MONTGOMERY COUNTY HISTORIC PRESERVATION COMMISSION STAFF REPORT

Address: 8804 Old Georgetown Road, Bethesda Meeting Date: 5/12/2021

(Bethesda Community Store)

PROPOSAL: Chimney removal, window alterations, and rear alterations

Artifact Description: Windows

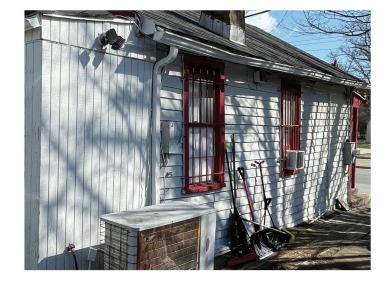
Staff finds that the existing windows to be replaced on the side/secondary elevations are relatively simple and nondescript, and that the proposed new windows will closely match the existing. This will result in a minimal visual change, at best. The existing four-lite storefront window has been previously altered with repairs, resulting in muntins of varying widths. Staff finds the proposal to replace this window with a

closely matching window with consistent muntins will not create a significant visual change. Therefore, staff finds that the proposed window alterations will not remove or alter character-defining features of the subject property.
